## 1999 Field Service Bulletins

<b>Issued By:</b> Technical Service	<b>Date Issued:</b> 1-99	<b>Distribution:</b> Service/Parts	<b>Supercedes:</b>
<b>Subject:</b> Reducing Turbulence	<b>Product Type:</b> RANGES	<b>Model No:</b> RSG	<b>Bulletin No:</b> 99-04

## RSG BRACKET

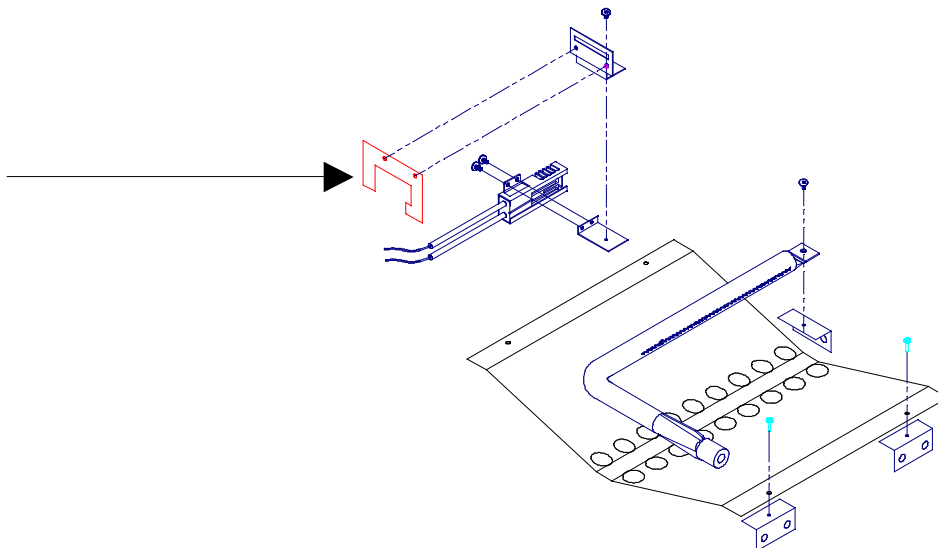
We have added a bracket to the RSG to reduce turbulence at the venturi of the bake burner. This bracket is mounted to the bottom pan at the inlet of the bake burner. The part number for this bracket is 36166.
